Independent Review of AFC 2A, 2B, and 2E ATR Irradiation Tests

January 2014

Prepared by an Independent Review Committee
M. Cappiello, Chair
R. Hobbins
K. Penny
L. Walters

FCRD-FUEL-2014-000578

Figure 3. Sequential Analysis Process

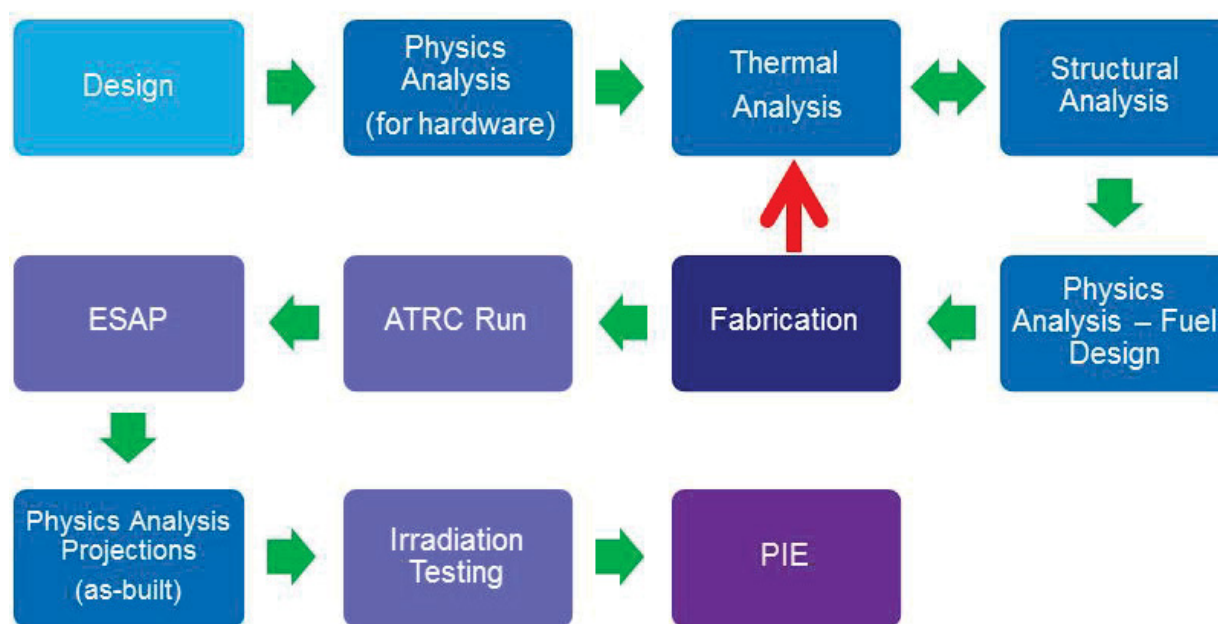
Currently the team uses a Sequential Design Analysis Process. We recommend an analysis using as-fabricated test hardware be performed as part of the process as illustrated by the red arrow in Figure 3 below. This final analysis would have likely identified problems with the high smear density in AFC-2. Current techniques need to use the more detailed coupled analyses as e.g., BISON (in addition to the safety related analyses). As part of the normal design process, worse case analysis using as-built dimensions and any fabrication uncertainties (enrichment, Pu content, gas composition and pressure) should be performed. Peer checks should be performed on all analyses.
